TRANS/WP.30/2000/14/Add.1
2 May 2000

**CUSTOMS CONVENTION ON THE INTERNATIONAL TRANSPORT OF GOODS
UNDER COVER OF TIR CARNETS (TIR CONVENTION, 1975)**

Validity of curtain-sided vehicles

Addendum 1

“Sketch No. 10

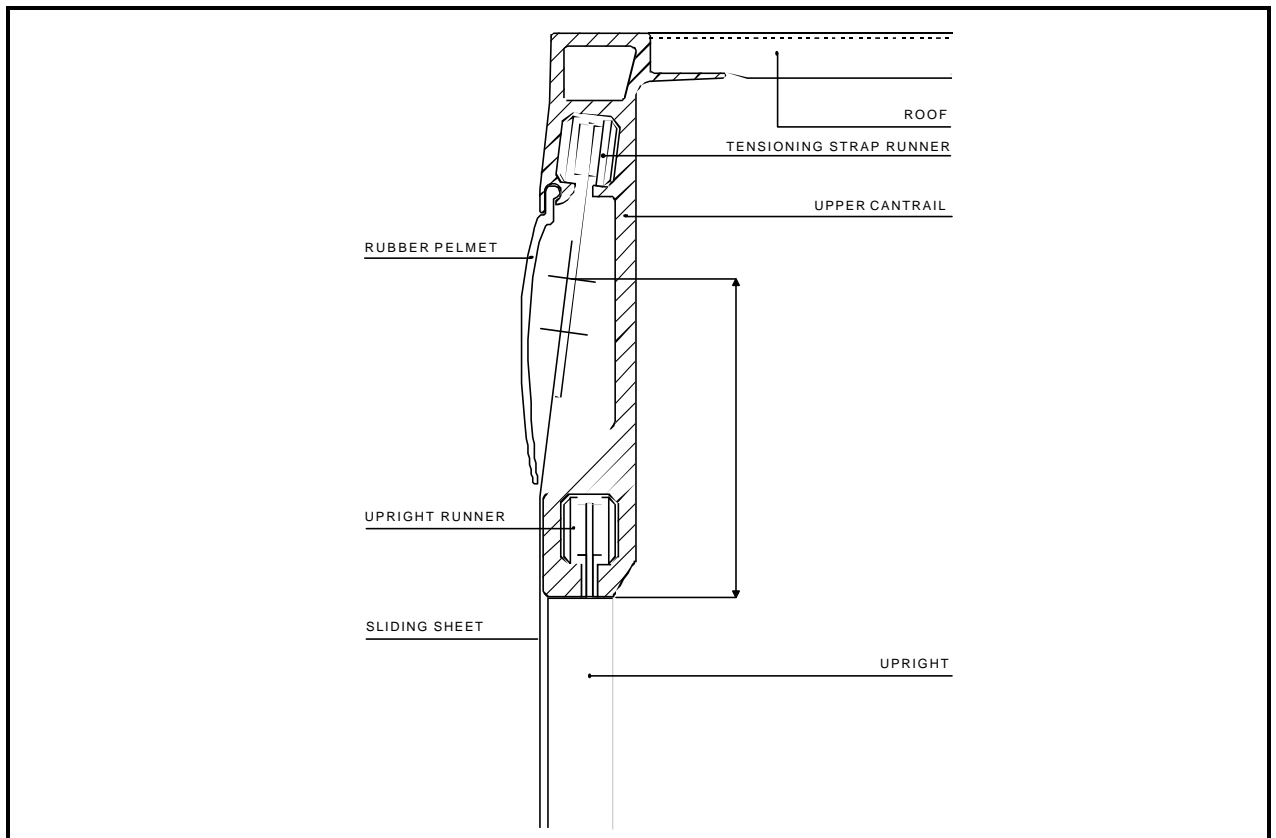
3. The secretariat proposes to amend the relevant provisions prepared by the UN/ECE group of experts as contained in document TRANS/WP.30/2000/14 with a view to inserting a sketch showing in detail the construction of the guidance of the sliding sheets.

Add the following sentence after the last sentence of Annex 2, new Article 4, paragraph 2 (iii):

Add the following new sketch to the existing sketches appended to Annex 2:

Add the following sentence after the last sentence of Annex 7, new Article 5, paragraph 2 (iii):

Add the following new sketch to the existing sketches appended to Annex 7:

“The system is described in sketch No.10 appended to this Annex.”

“The system is described in sketch No.10 appended to this Annex.”
